# **SCAG POWER EQUIPMENT**

#### **SERVICE INFORMATION SHEET 198**

### New Polyurethane Discharge Hose and Ratchet Style Retaining Straps For Scag Truck Loaders

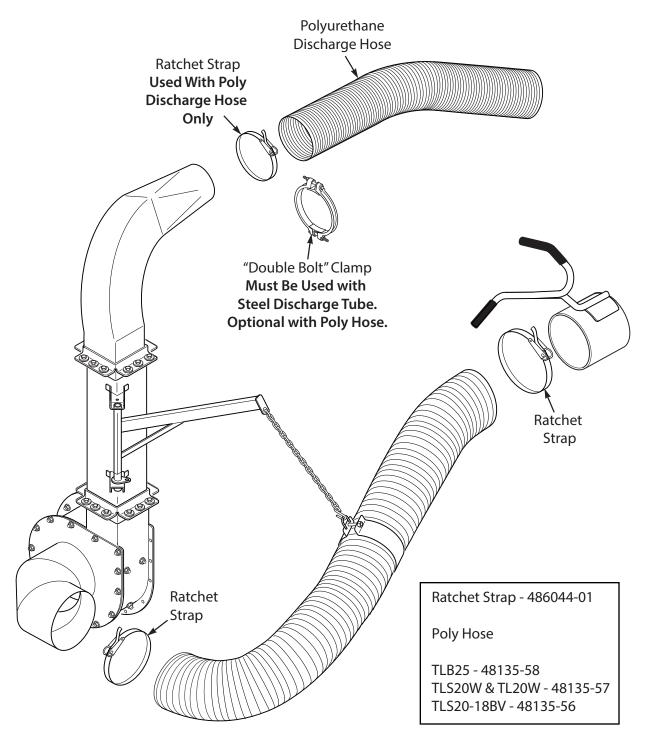
In order to accomodate requests from the field, Truck Loaders are now being shipped with a polyurethane discharge hose in place of the corrugated metal tube that was used in the past.

In addition to changing the hose material, we are also transitioning to a ratchet type retaining strap for use in securing the poly hose to the machine in place of the cast "double bolt" style clamp used with the previous metal discharge tube. See Page 2.

As with the polyurethane discharge hose, the new ratchet strap(s) will also be used to secure the debris intake hose to the truck loader and intake nozzle.

Please note that this shift to the ratchet style retaining straps is a running change. During this transition you may receive product with the new poly discharge hose and the cast double bolt style clamp for the discharge hose along with "bridge type" hose clamps for the intake hose to truck loader and intake nozzle connection points.
